RE: **Palen Solar Power Project, Docket No. 09-AFC-7**
Responses to January 14, 2010 CEC Workshop Queries
Technical Areas:
Soil & Water Resources (supplemental data for DR-S&W-242)

Palen Solar Power Project

Soil and Water Data Responses to January 14, 2010 CEC Workshop Queries

DR#242 Supplemental---Soil and Water:

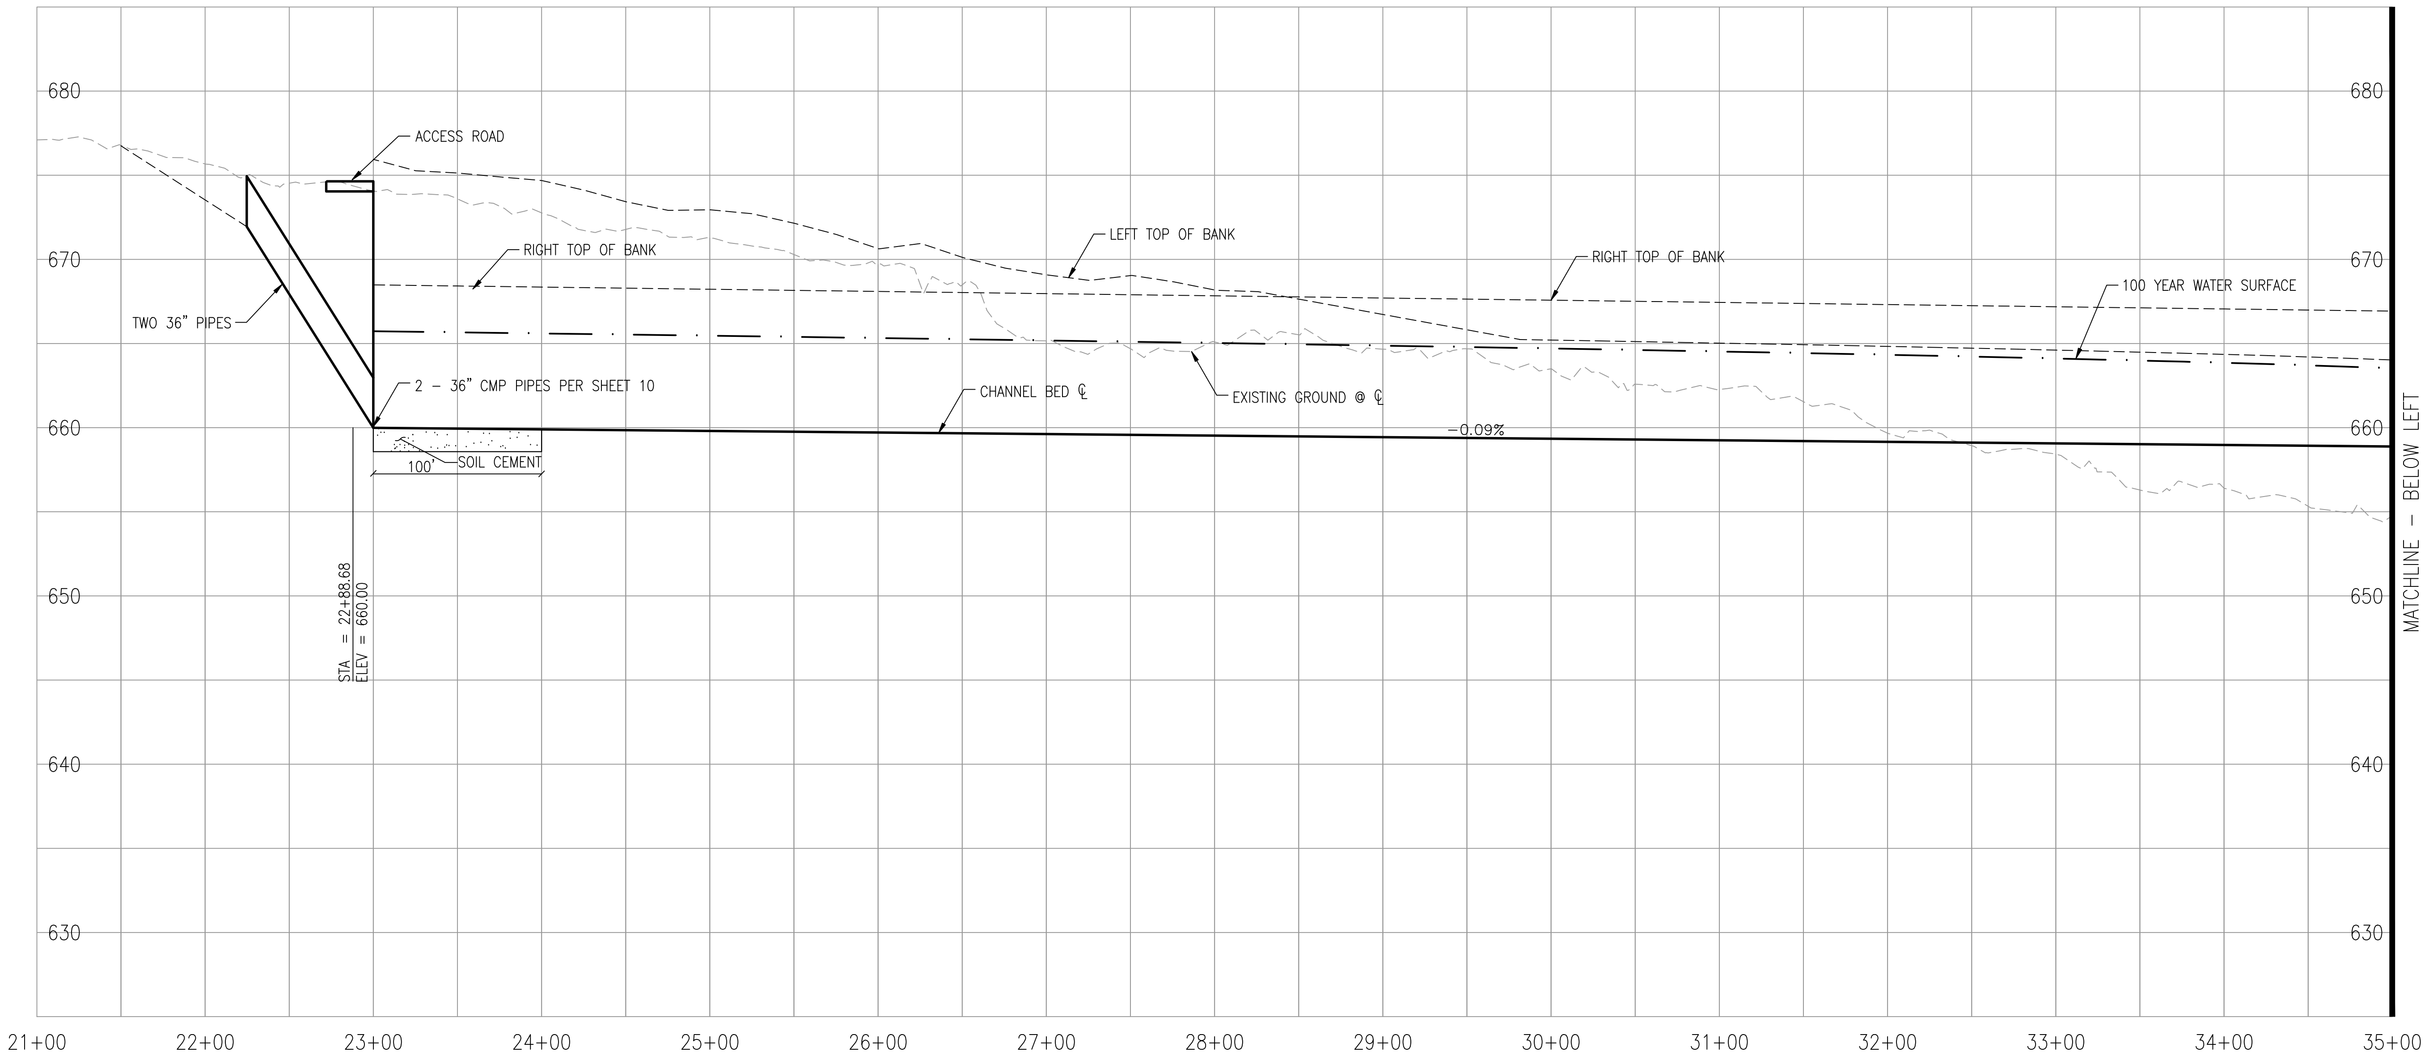
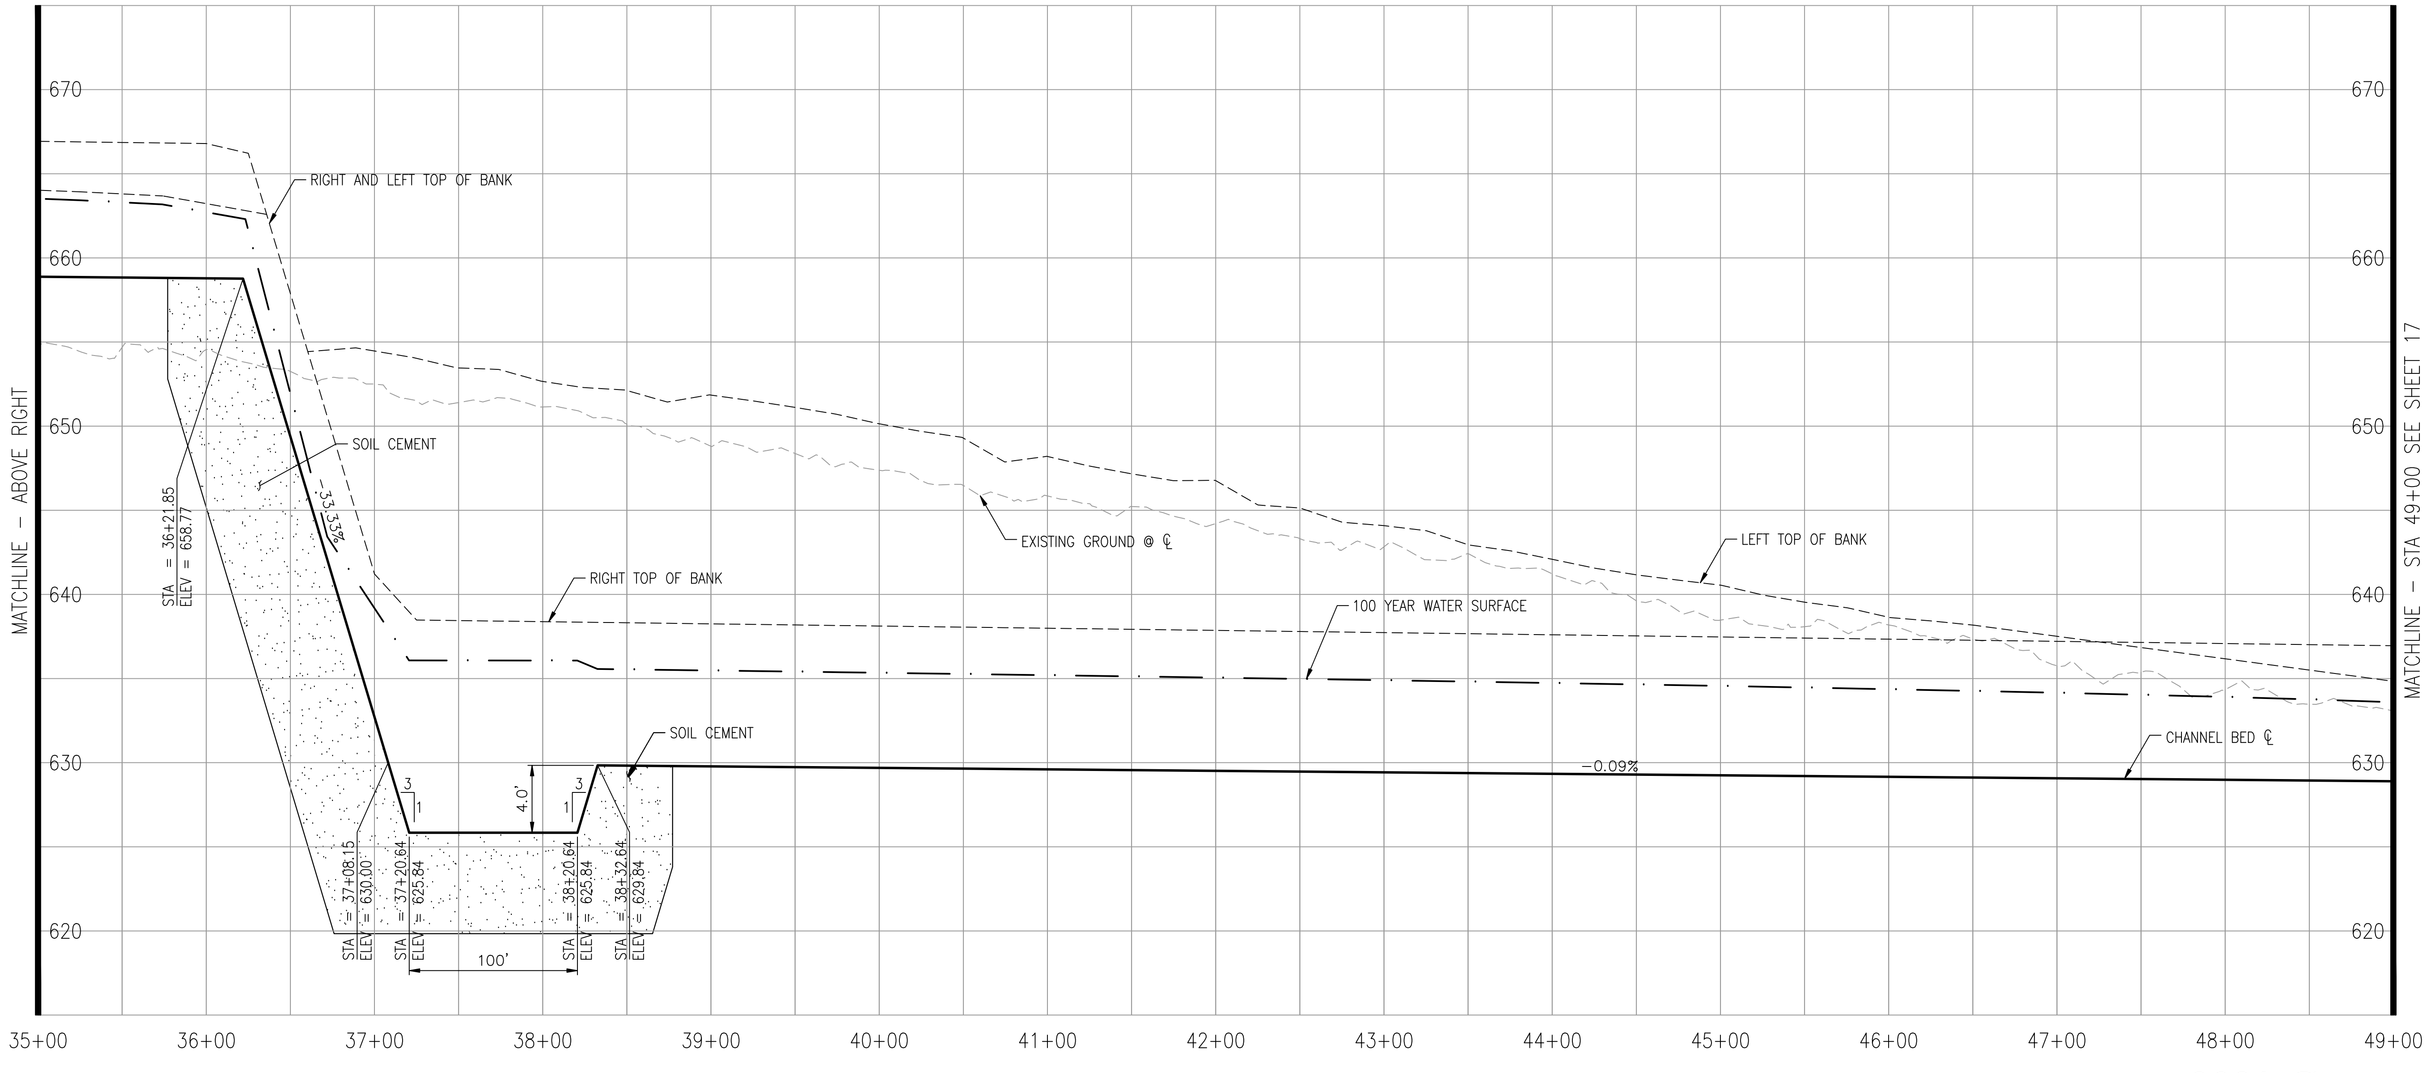
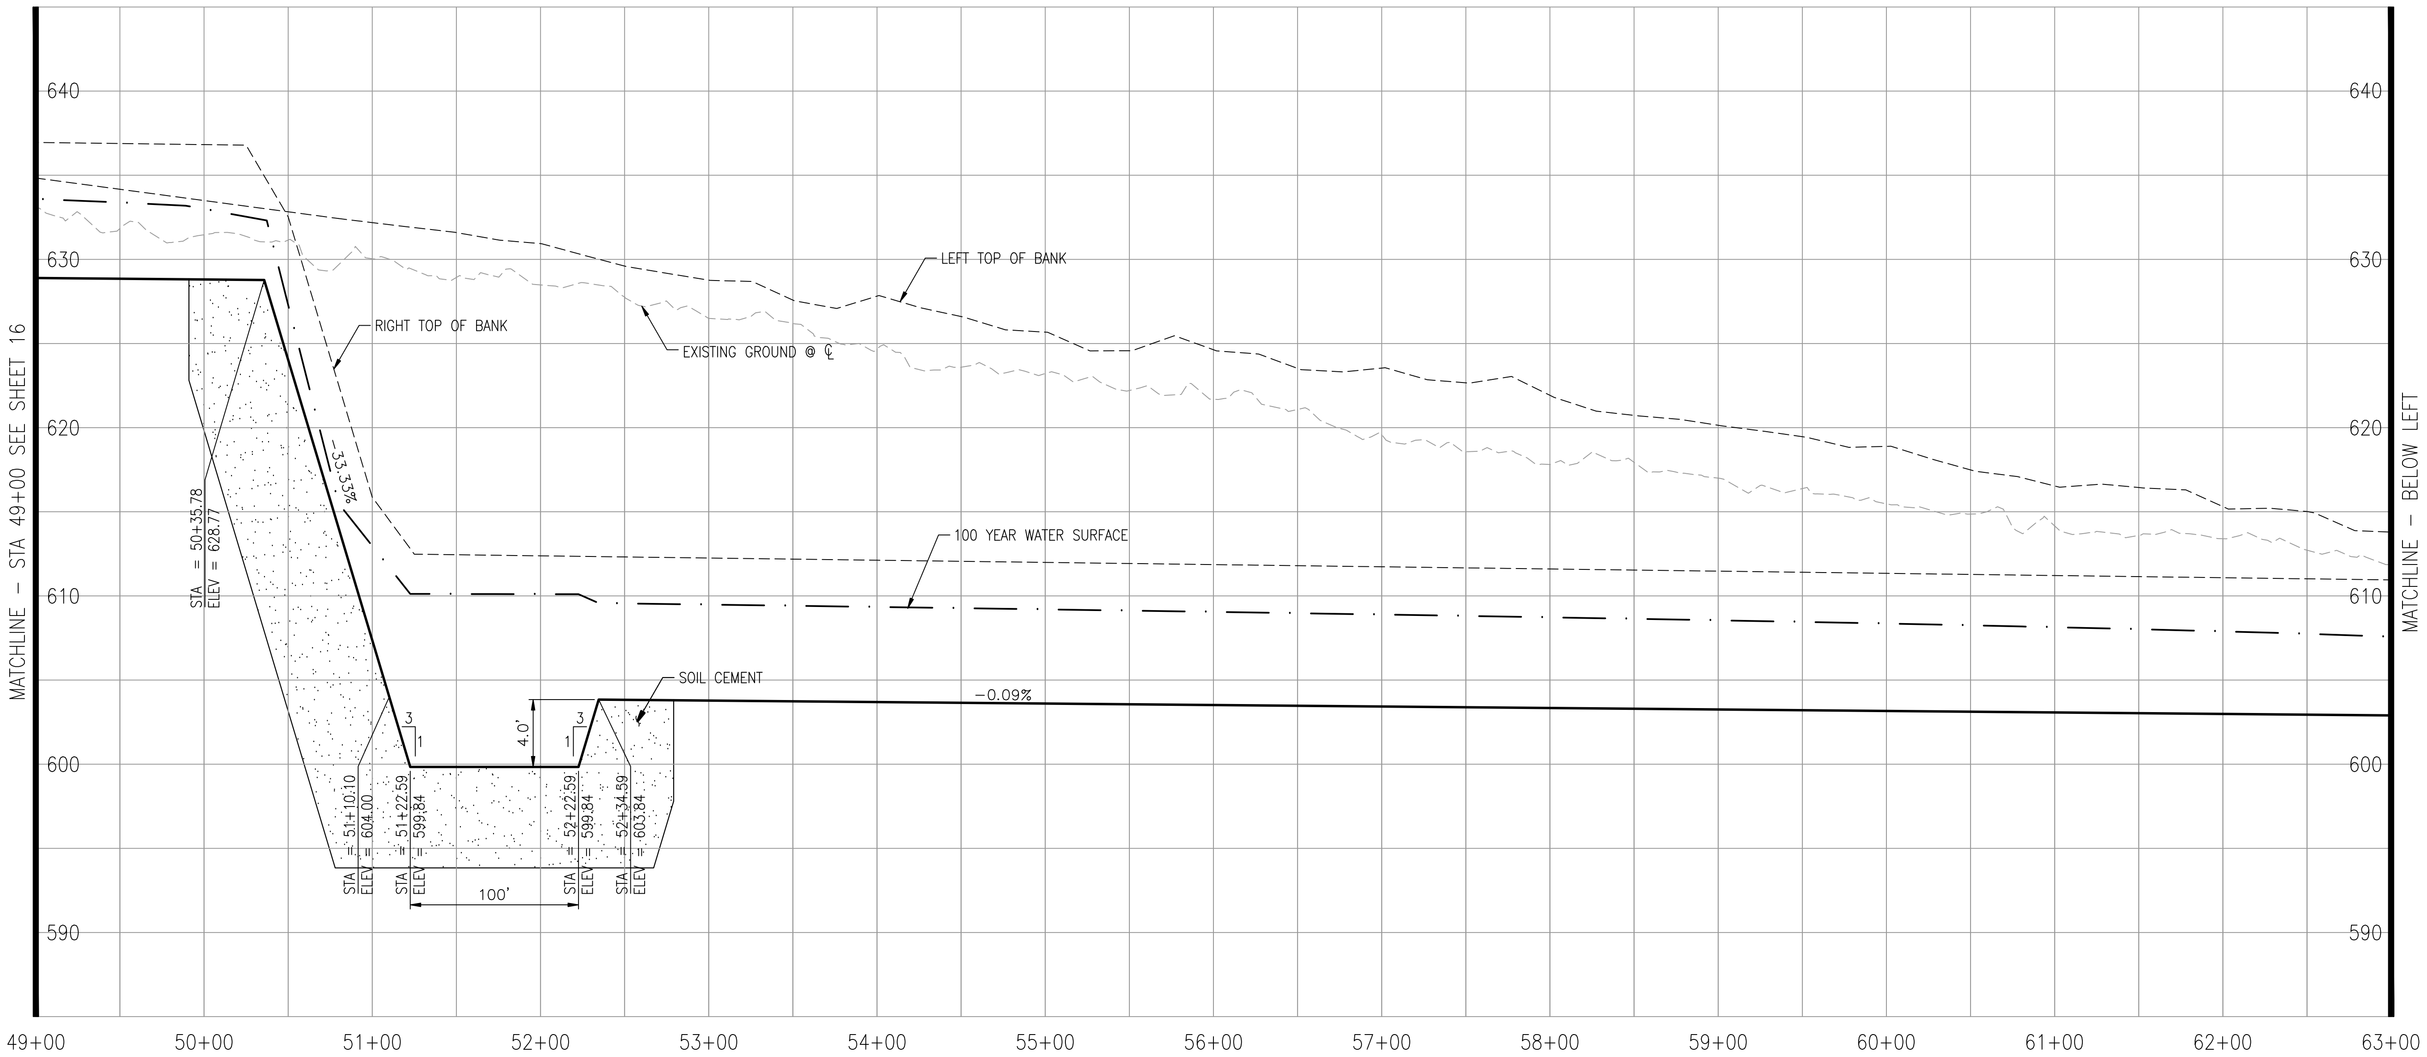
Add 100-yr. water surface elevations on profiles for main channels (both collectors and conveyance).

The 100-year water surface profile has been added to the plans and is provided as part of this response.
